SEWAGE DISPOSAL TESTING

HOWARD COUNTY HEALTH DEPARTMENT
ENVIRONMENTAL HEALTH SERVICES

FIELD LOCATED PERC HOLE
LOT 1 ABIE BROADWATER PR
TAX MAP 28
5TH ELECTION DISTRICT
HOWARD CO. MD
SCALE 1" = 50' JUNE 19, 198

A Broadwater Lot 1

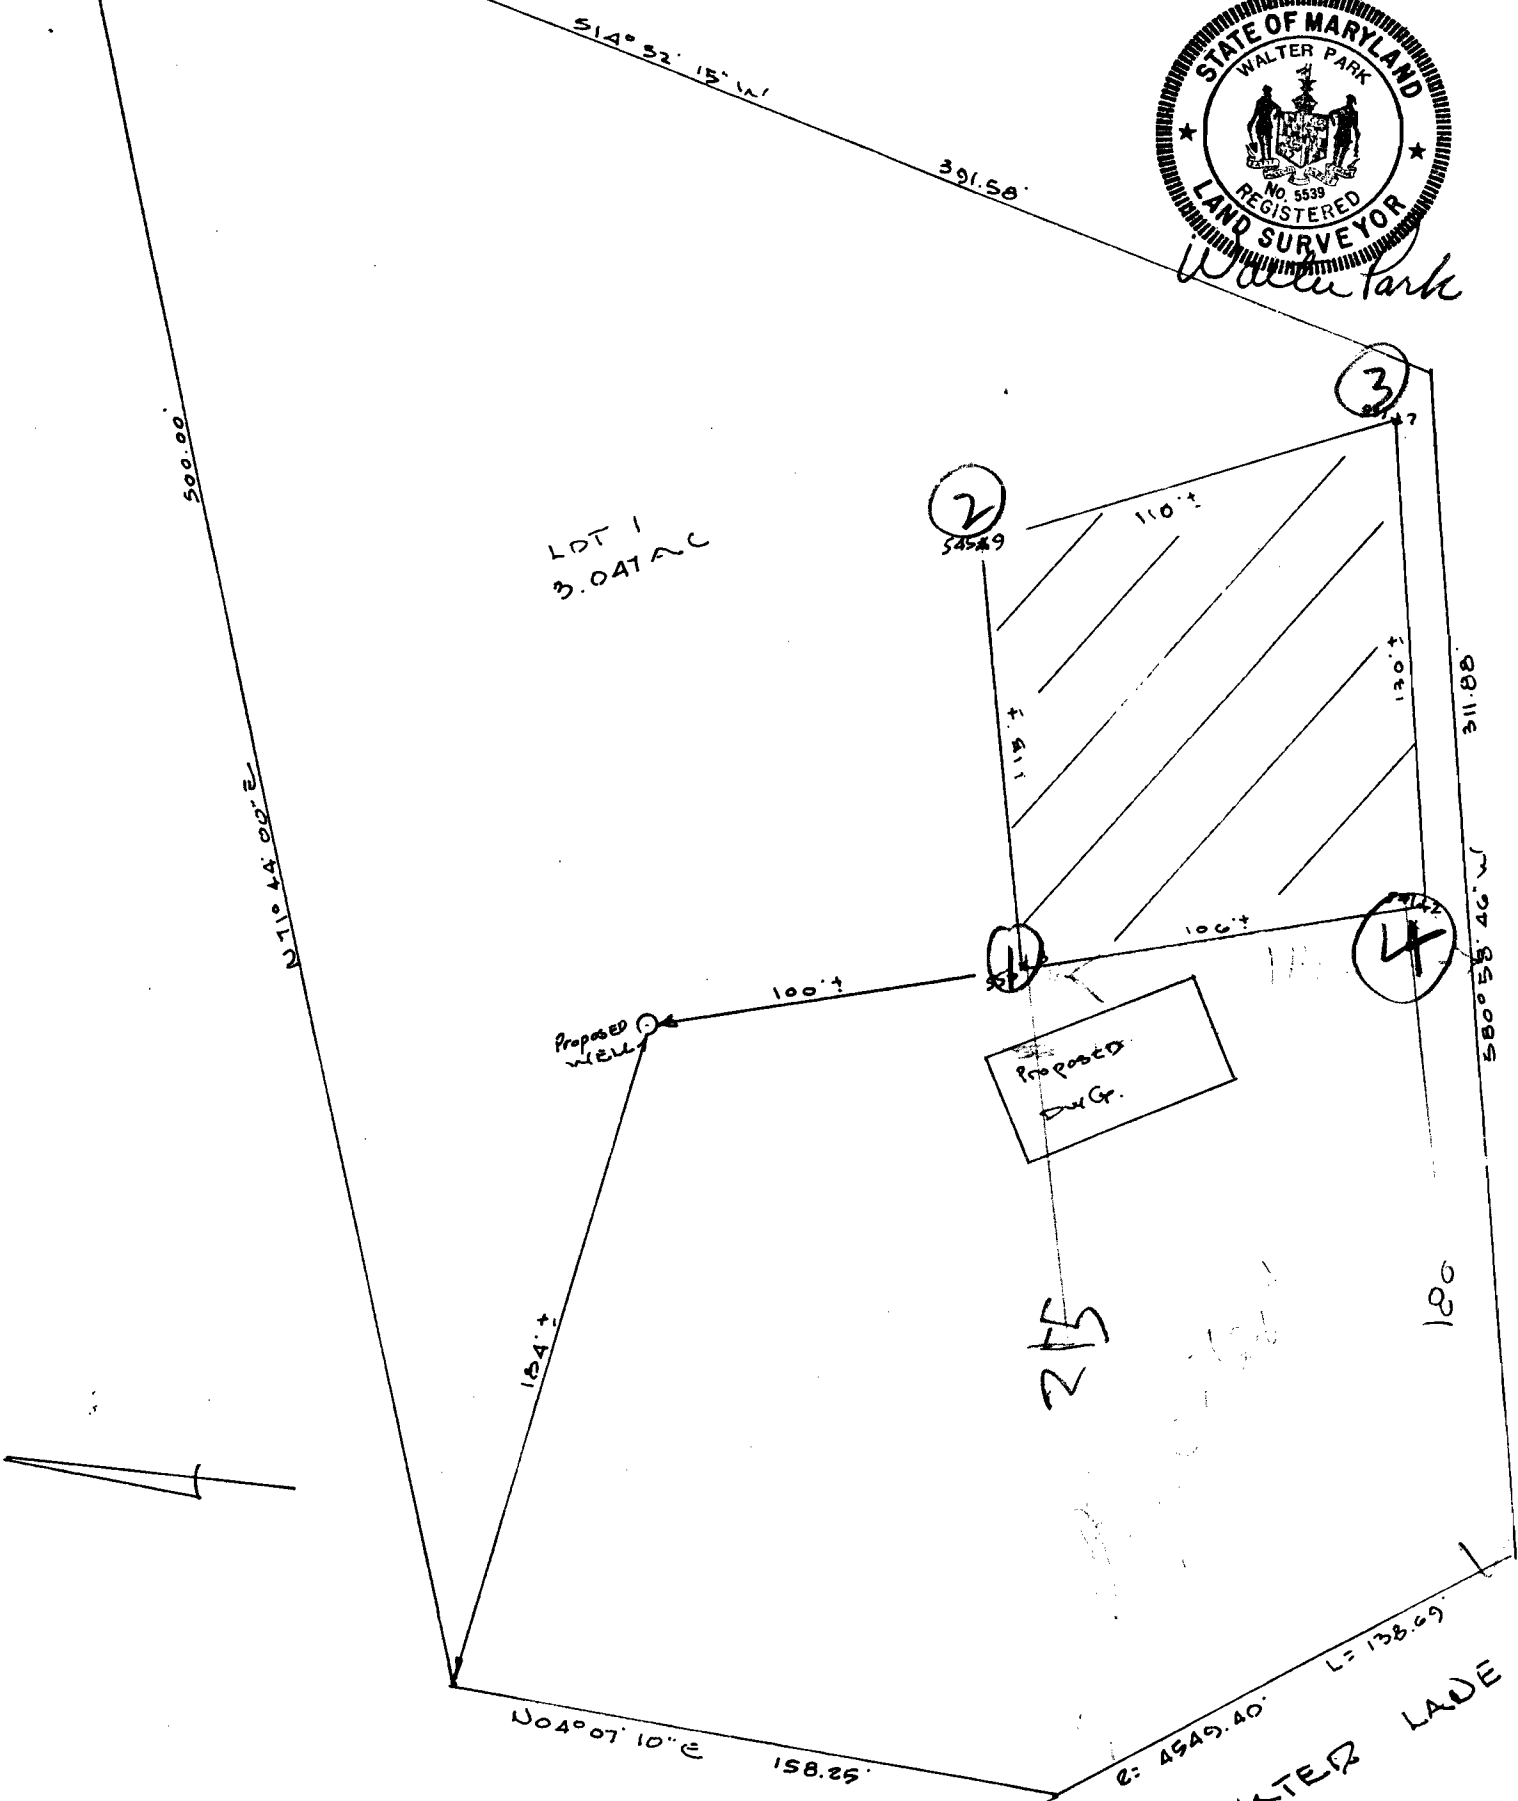
8/20/81 Plat Rejected

- ① No perc Cert Plat (also called preliminary)
- ② No minimum ownership statement
- ③ No field location of perc Hole

Perc Cert Plat not right Elev of House site
& well site not shown & House is too close
to sewer & septic treatment. Old Sewage Treatment

⑤ Statement on Perc Cert Plat instead of New Plat
Told W. Park He will come in today & correct

13/1/81 - Talked to Mrs Pover. She
said Walter Park picked up first
plat for work.
The revised prelim. perc. cert. plat
was left & was OK except
the location of the proposed house
was left off. Called Walter Park
busy.

9/1/81 The final Plat was returned & is OK
now. However the prelim. perc.
cert. plat does not have
location of house. Called W. Park, Walter

He will correct ② ③ & I will check
on ① with F.S. if necessary

10/4/81 Final Plat & Preliminary Plat
ready for signature.
Plats corrected & inspected by R/H
